**Origination Form**  
Proposed Revisions to a Standard Plans Index

<b>Originator:</b>	Gibbs, Shae	<b>Index Number:</b>	646-001
<b>Date:</b>	9/4/2025	<b>Sheet Number(s):</b>	1
<b>E-mail:</b>	shae.gibbs@dot.state.fl.us	<b>Index Title:</b>	Aluminum Post and Pedestal Mounted Pedestrian Detectors and Signals

ALUMINUM POST AND PEDESTAL MOUNTED  
PEDESTRIAN DETECTORS AND SIGNALS

INDEX  
646-001

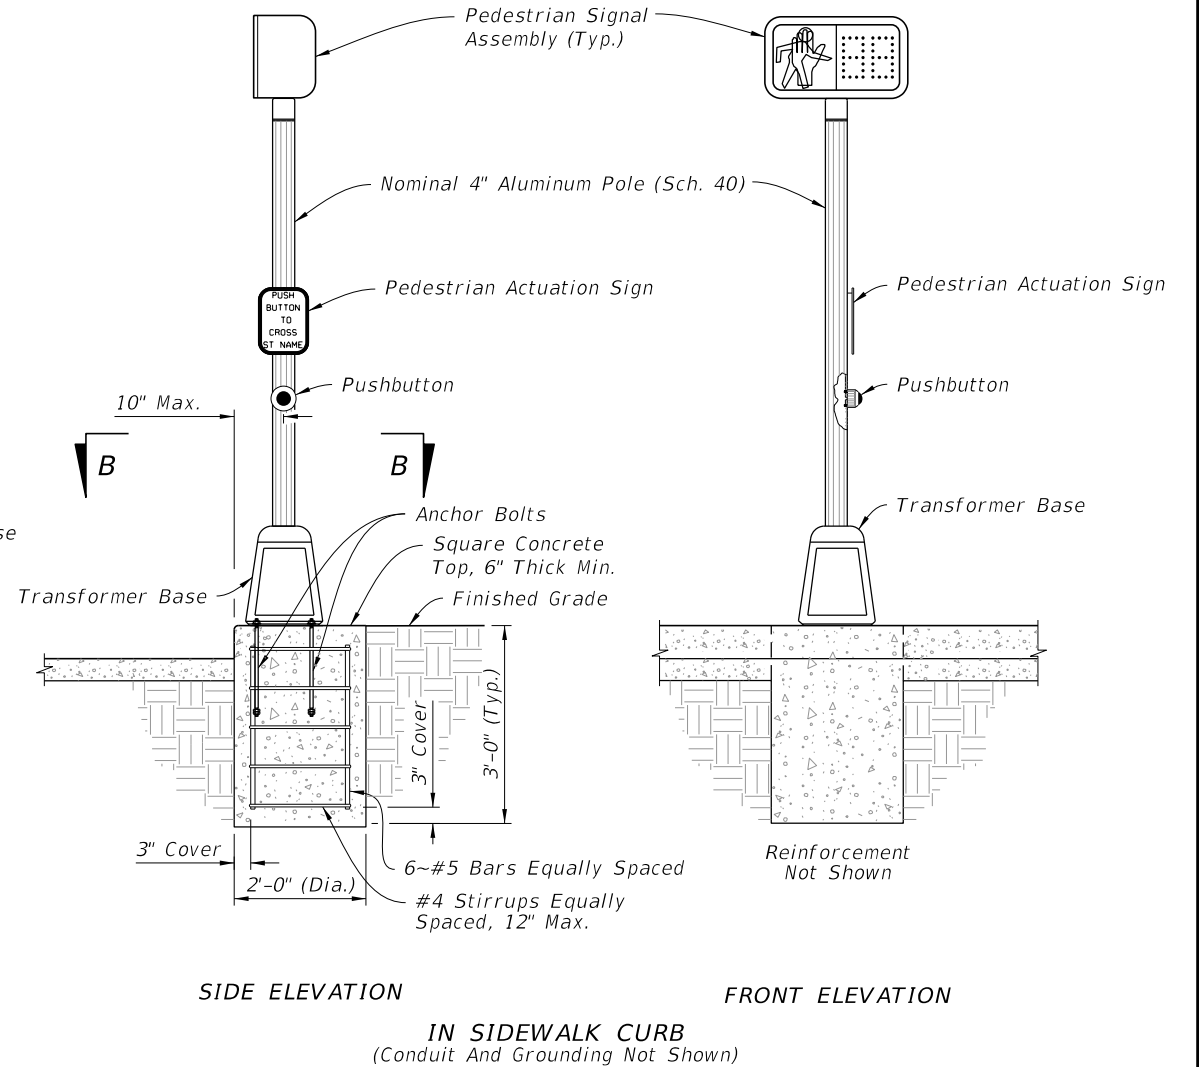
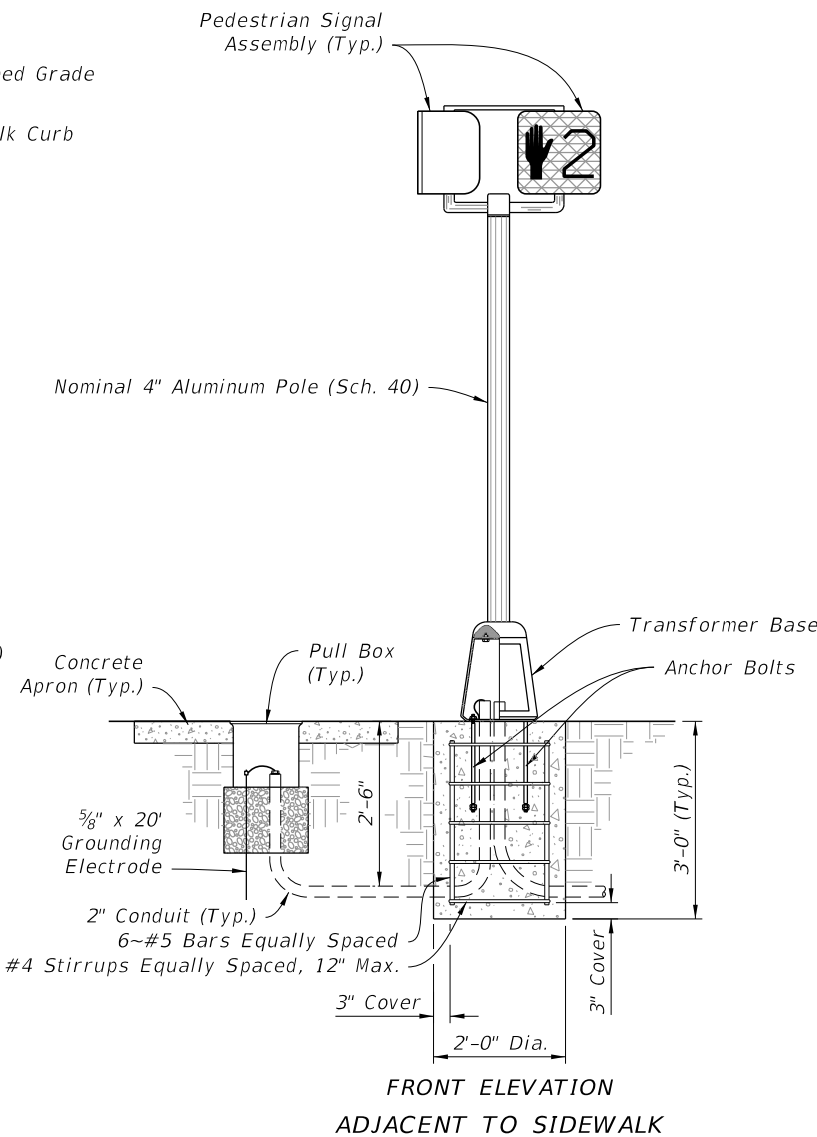
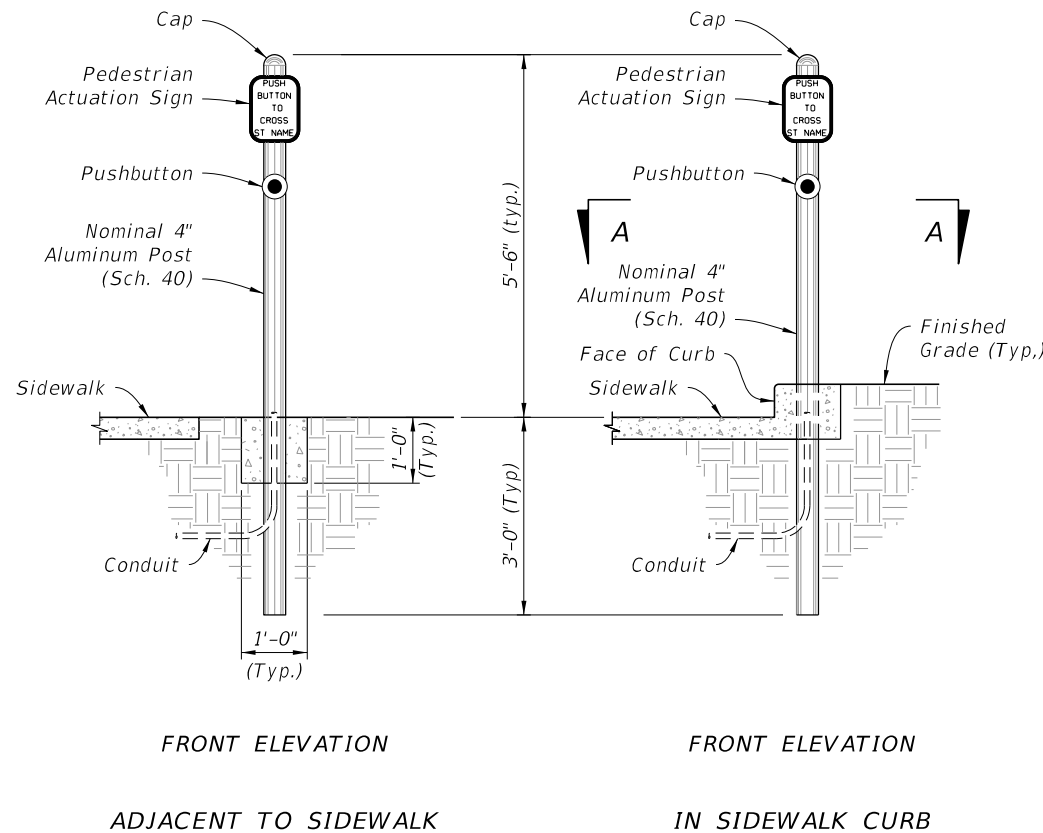
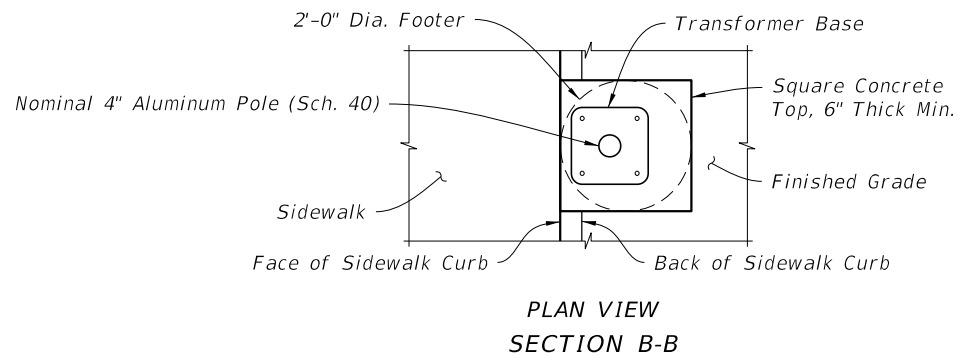
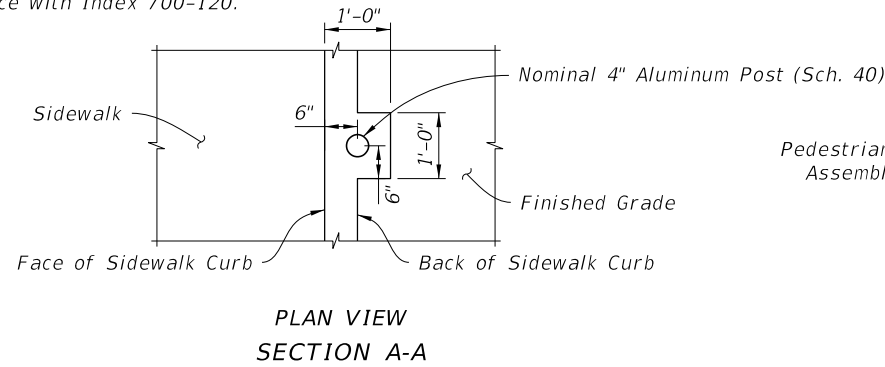
Sheet 1: Added Note 7 "For pedestrian mounted signals, route and terminate the grounding electrode conductor to a ground lug within the transformer base."

**7. For pedestrian mounted signals, route and terminate the grounding electrode conductor to a ground lug within the transformer base.**

This note was added to correspond with Standard Plans Index 653-001 in coordination with the TERL.
